- 12/19/18 CK - COMPLETED DESIGN FOR CLIENT & CITY REVIEW.
- 02/18/19 CK - UPDATED PER CITY REVIEW COMMENTS.

Uintah View Estates Improvement Plans

OGDEN CITY, WEBER COUNTY, UTAH
DECEMBER 2018

Sheet **8**
7 Sheets

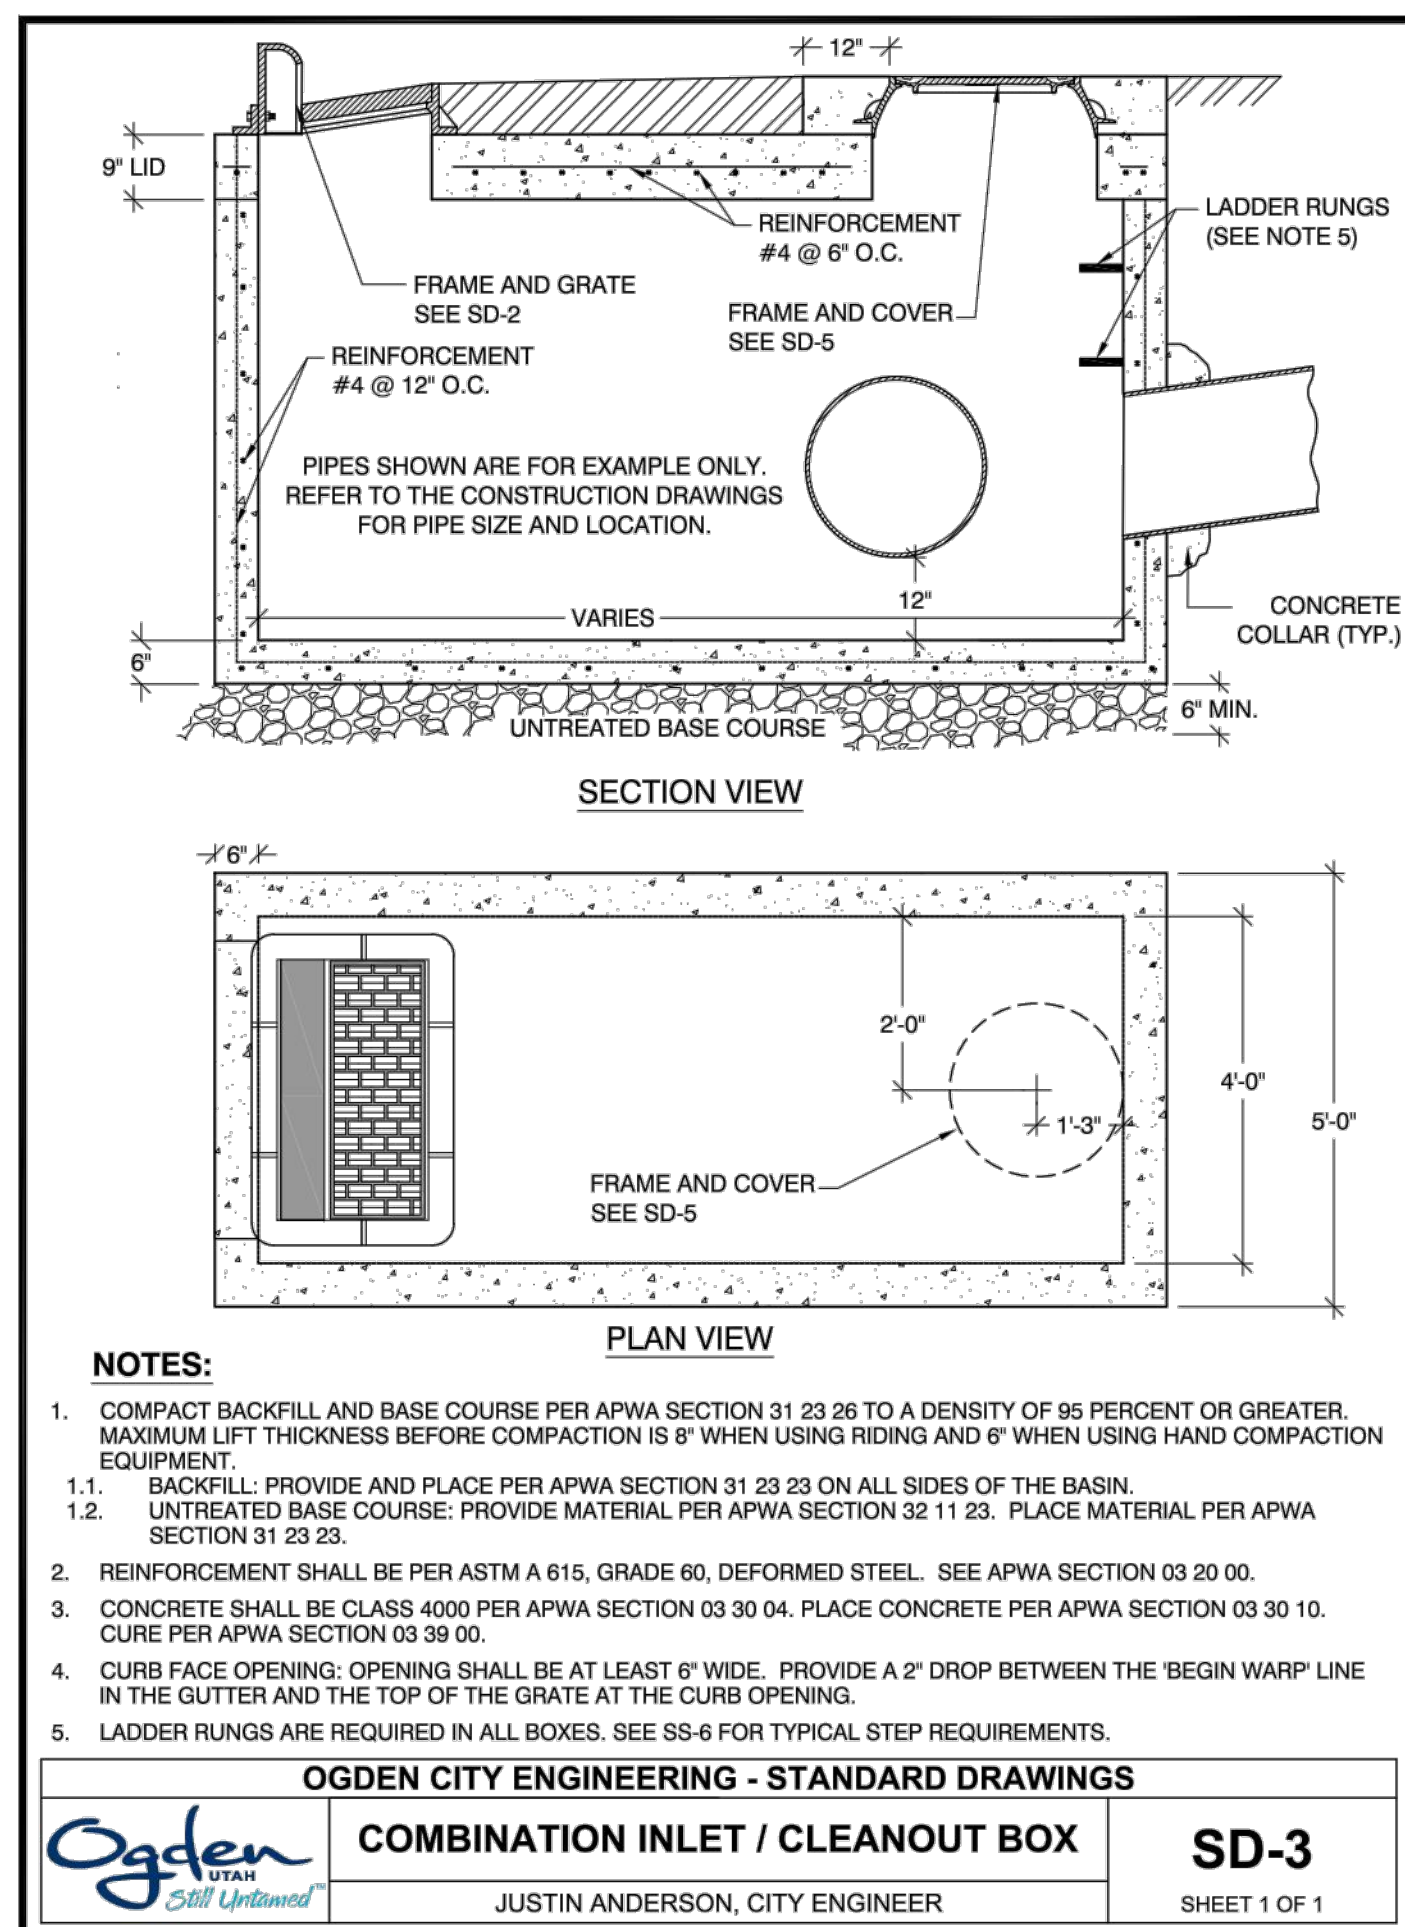
Use Weber County or APWA Specifications.
